YAMAHA MEASURE REPORT

MODEL	TDR240/250, TZR250	FILE	
SUBJECT	PISTON MELTING AT CROWN

MODEL	TZR250 '87, '88	FILE	
SUBJECT	PISTON SEIZURE

MODEL	TZR250 '87, '88	FILE	
SUBJECT	PISTON RING BREAKAGE

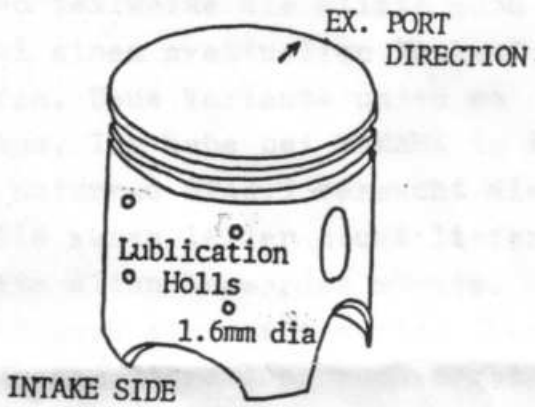
At the early breake-in of an units, some units may be experienced scaffing between piston and cylinder wall insurficient lublication. Then scaffing caused to piston seizure.

To prevent scaffing at early breake-in, we are going to change the piston desigen as similure with 2YK type (TDR250) as a next model. The 2YK type piston has four location of lublication hoils at intake side as shoun in the left. These holls will provide greator lublication effect between piston and cylinder wall comparison with present ones.

If you encounter a smilure problem, please recommend your dealer to use following part instead of STD ones. Recommended piston is as same as TDR250 model's one.

PART NAME	STD	RECOMMENDED
Normalmaß	PISTON STD	~~1KT~~ 2RH-11631-01-35	2YK-11631-01-35
1. Übermaß	PISTON 1ST O/S	1KT-11635-01	2YK-11635-01
2. Übermaß	PISTON 2ND O/S	1KT-11636-01	2YK-11636-01

Alte Variante

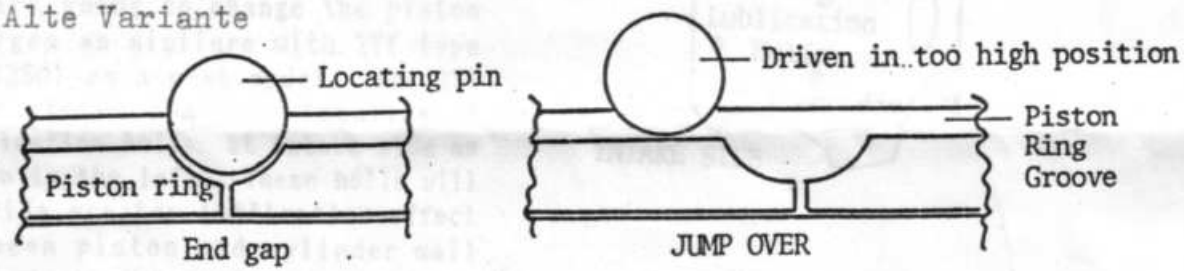
Market report indicates that the a piston ring is broken catching with cylinder port.

The piston ring located pin may be experienced driving into piston ring groove with insurficient dimension accuracy in some units (drivig upward'comparison with specified location) . And also locating pin can be worn. These matter may cause that piston ring end gap can jump over the locating pin and then end gap will catch with cylinder ports. See below.

YZ TYPE LOCATING PIN

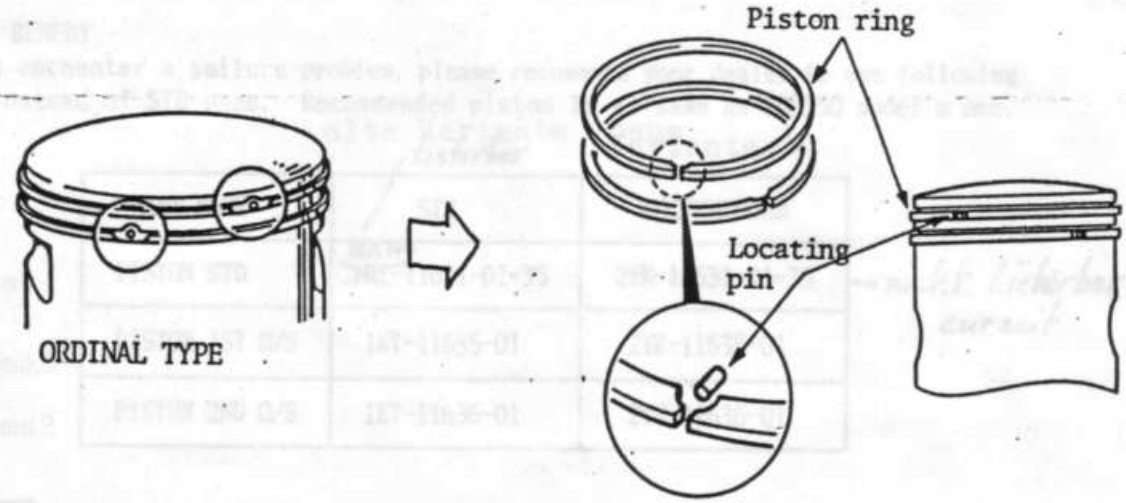
To prevent jumping over, locating method of piston ring will be changed to YZ type as shown in below. Now we are investigating this remedy to employ with next model.
